Subject: **Request for Modification to Individual Permit Application and 401 Water Quality Certification** for the US 64 Relocation from US 19/74/129 in Murphy to east of NC 141 in Peachtree, Cherokee County. State Project No. 8.1910203. Federal Aid Project FR-14-1(1). TIP No. R-0977A. NCDOT Division 14. Debit \$570.00 from WBS Element 34357.1.1

The purpose of this letter is to request a modification of the existing Section 404 IP and Section 401 WQC. The activities and impacts occurring at each site are described, and revised project impacts are listed in Tables 1 and 2. Permit drawings and a Rapanos package are attached to this permit modification application. The EEP Acceptance Letter will be forwarded upon receipt by NCDOT.

PROJECT 8.1910203 (R-977A)
PROPOSED US 64 RELOCATION FROM
EXISTING US 19-74-129 IN MURPHY
TO EAST OF NC 141 IN PEACHTREE

TRI-COUNTY COMMUNITY COLLEGE MOD. - MARCH 2008 SITE 16B
 DB 409 PG 75
 DB 363 PG 27
 DB 310 PG 81
 DB 306 PG 121

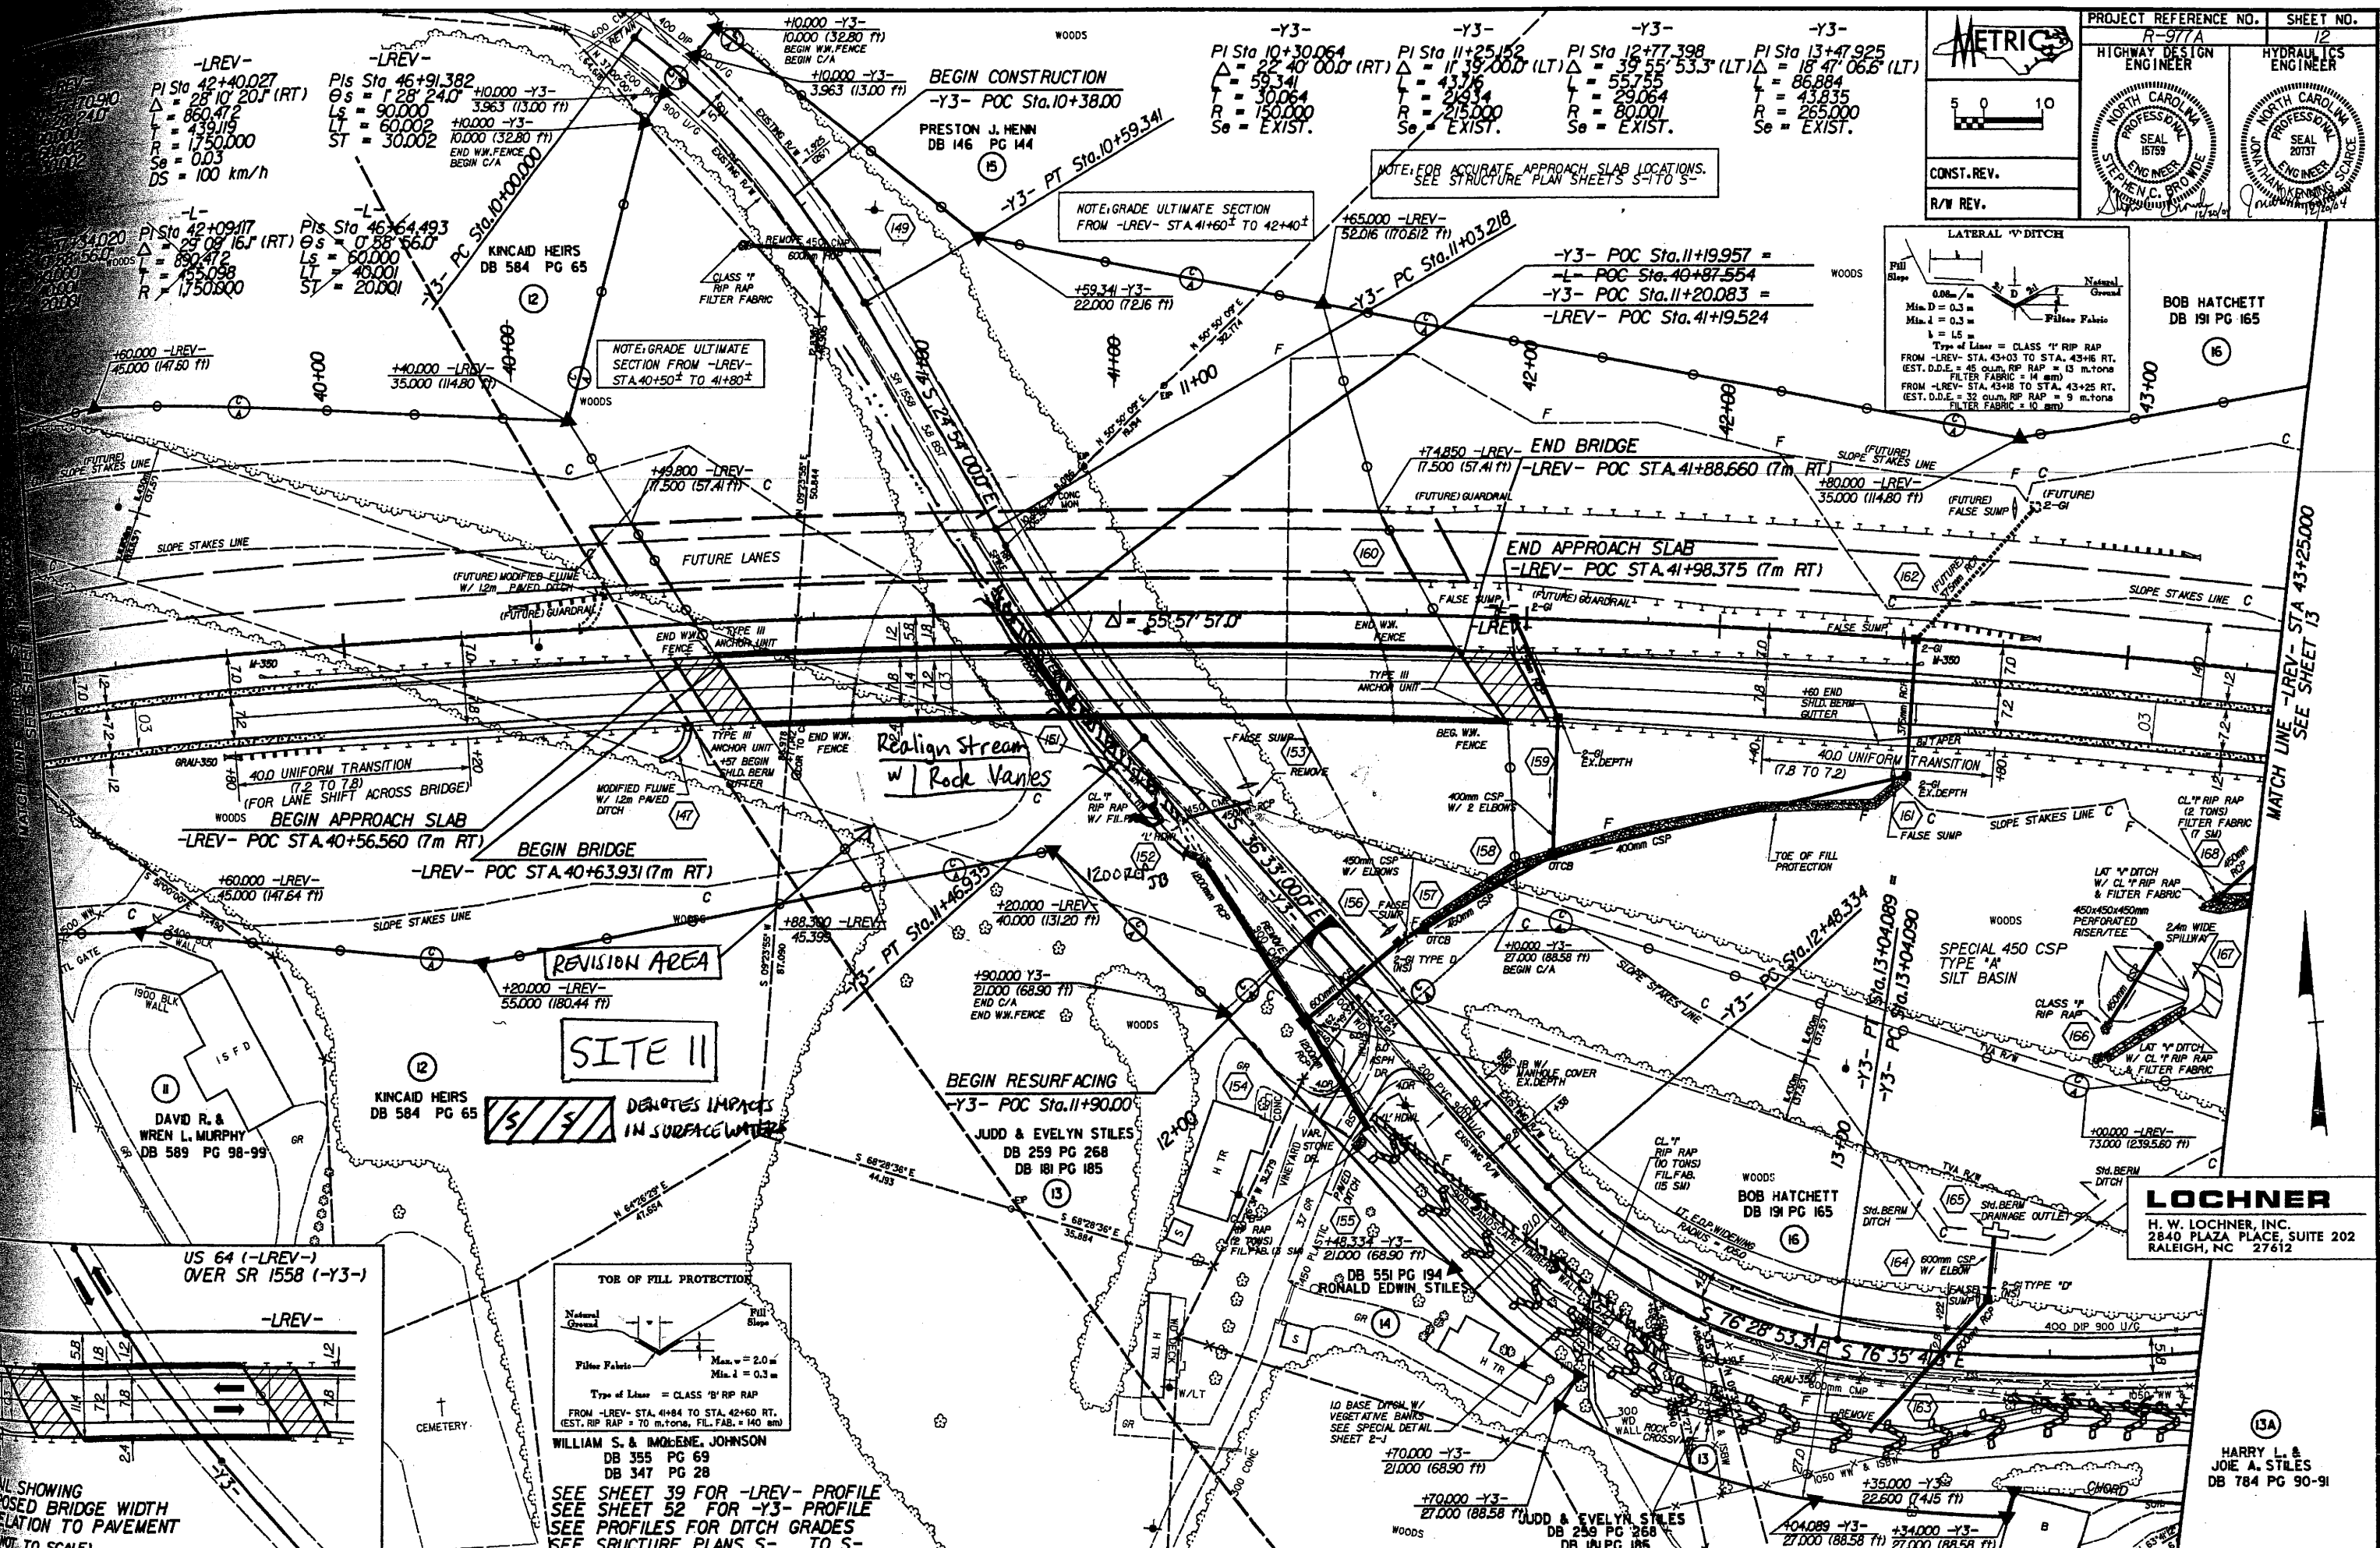
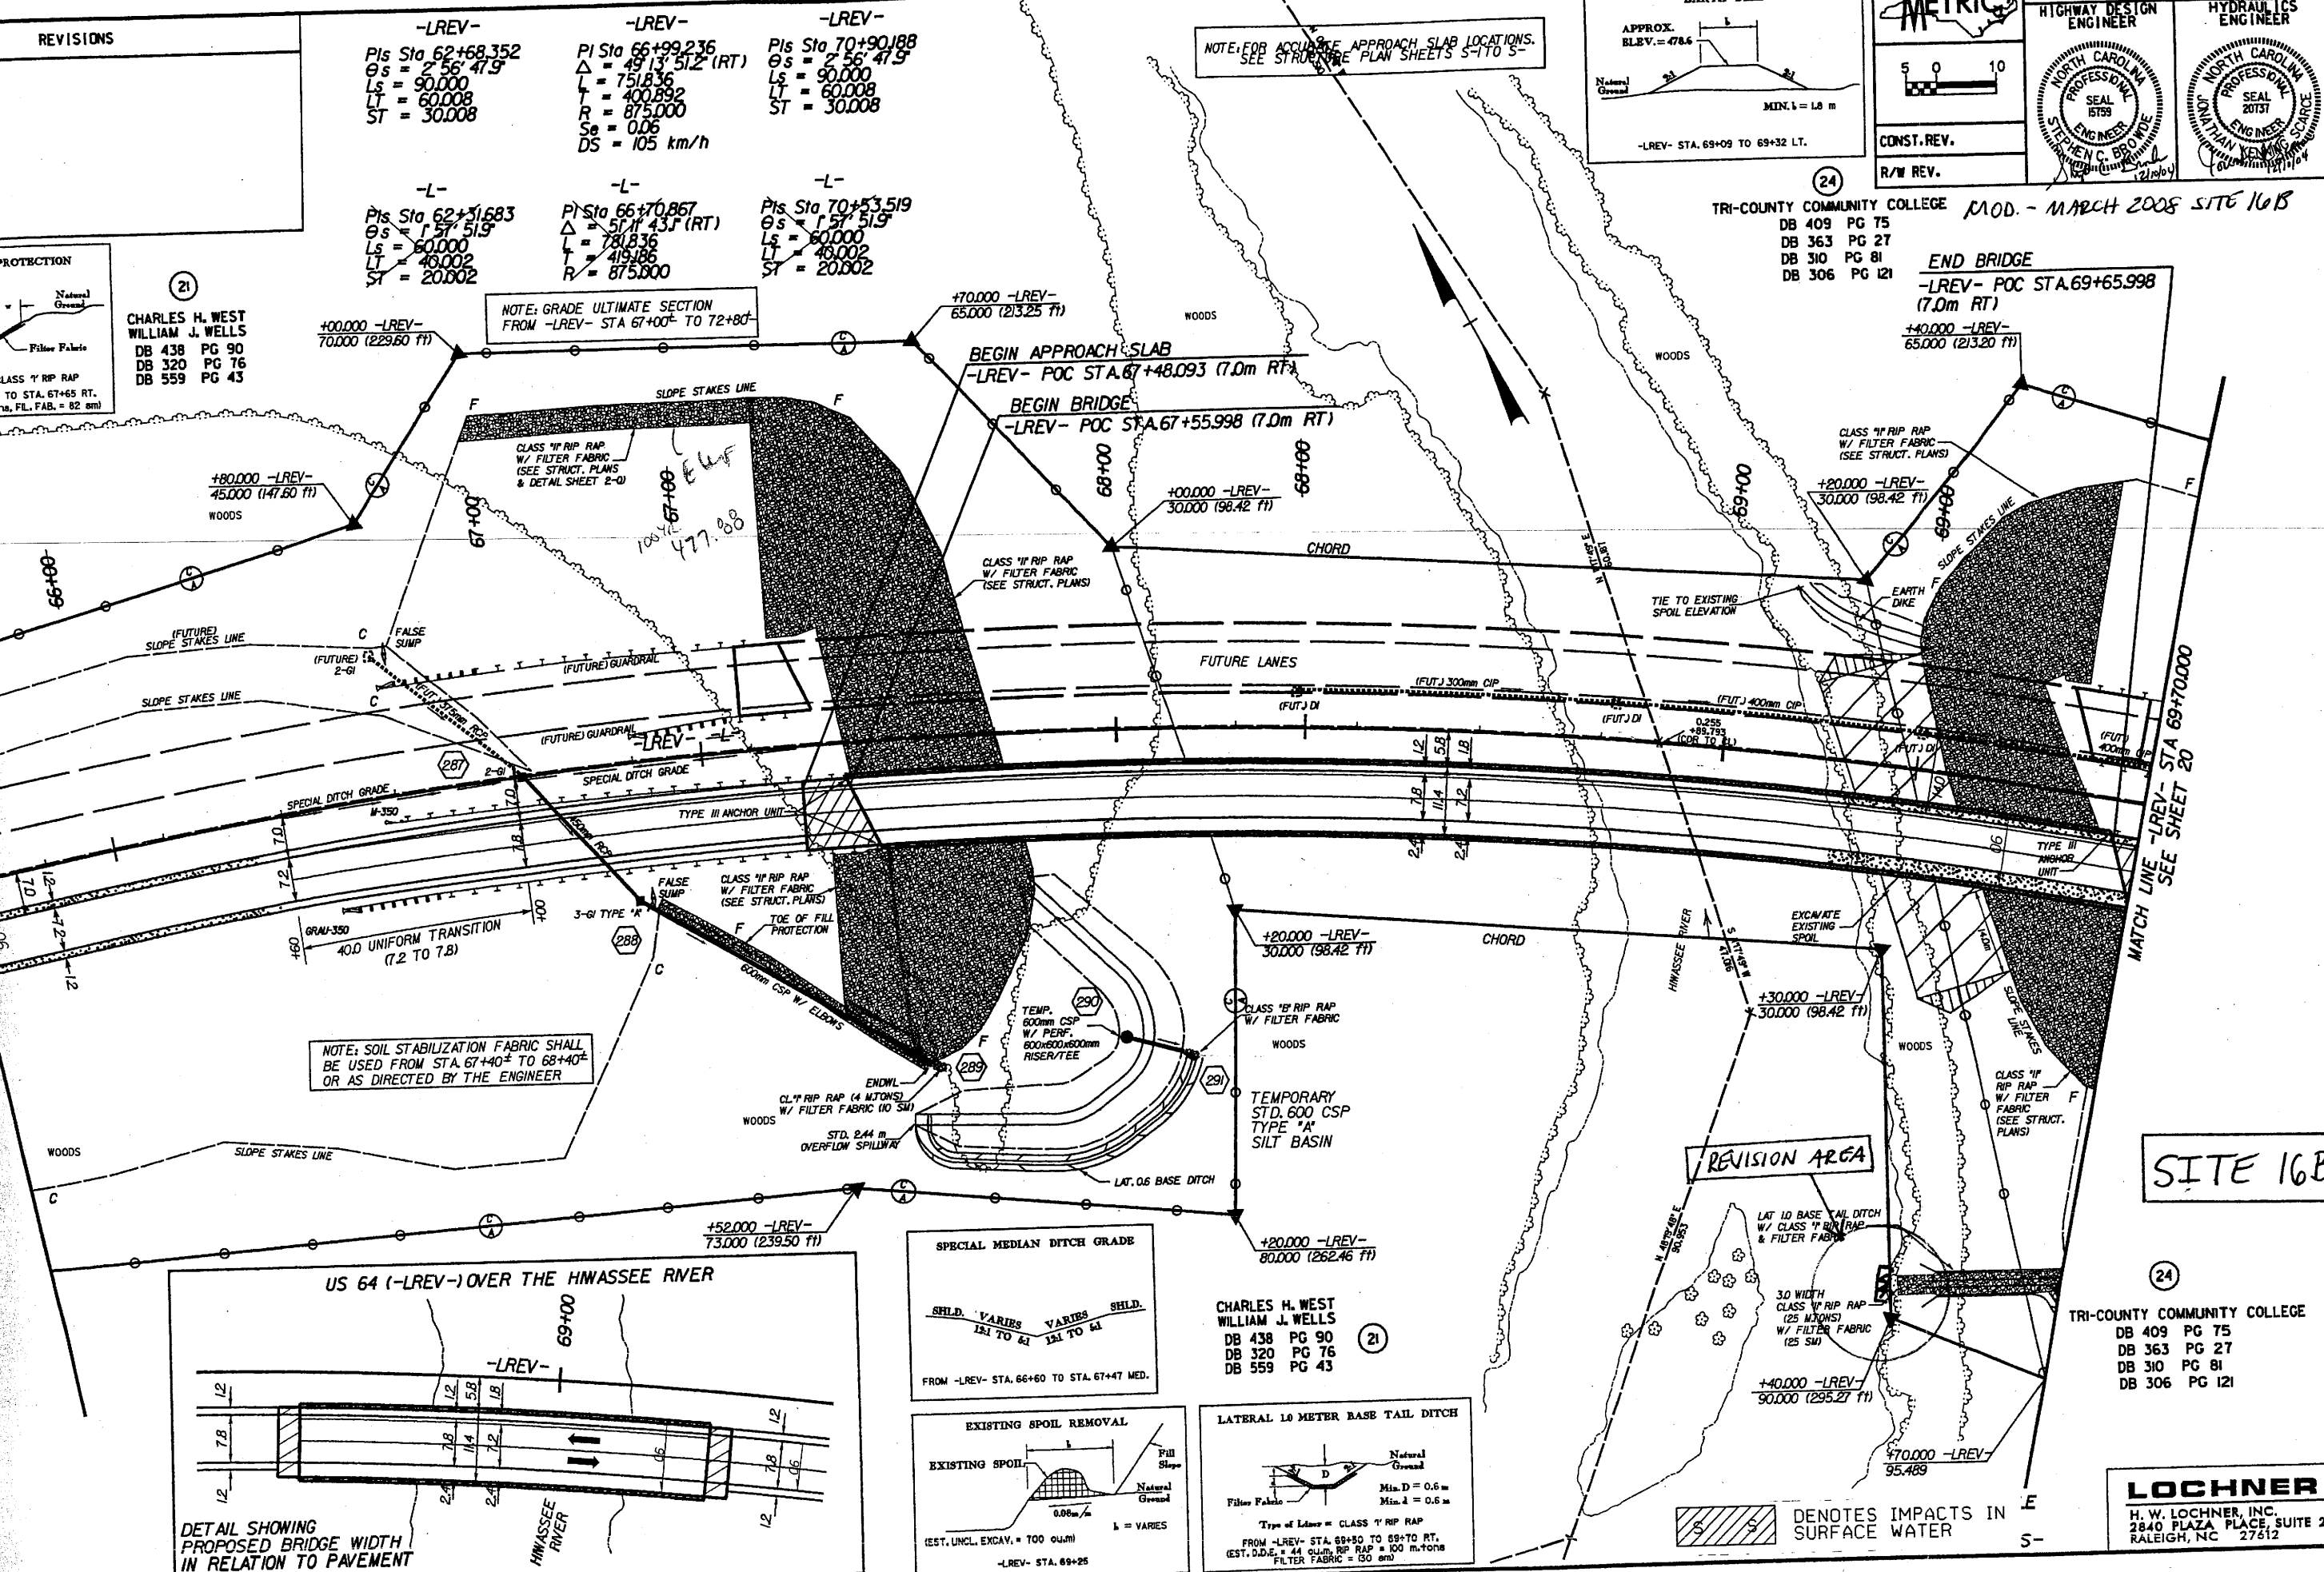
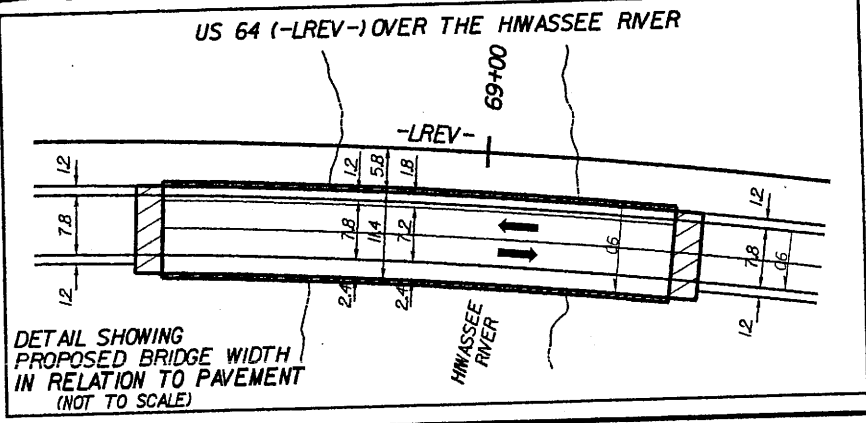
Modification activity at Station 69+37 -LREV-RT- (see Mod-April 2008 Site 16B Sheet)

Due to potential erosion and scour problems along the streambank of the Hiwassee River where the riprap-lined tail ditch confluences with the river, DWQ suggested that NCDOT extend the riprap-lined ditch an additional 20 feet down the slope to the Hiwassee River. The original plans show the tail ditch ending at the top of the streambank, which is 12 to 15 feet high. This tail ditch drains a hazardous spill basin, which collects stormwater from bridge number 5 spanning the Hiwassee River. Twenty feet of streambank along the Hiwassee River will be stabilized with riprap.

New Impact: **20 LF of new stream impact**

Mitigation: mitigation is not warranted for streambank stabilization, as it does not constitute loss of Waters of the U.S.
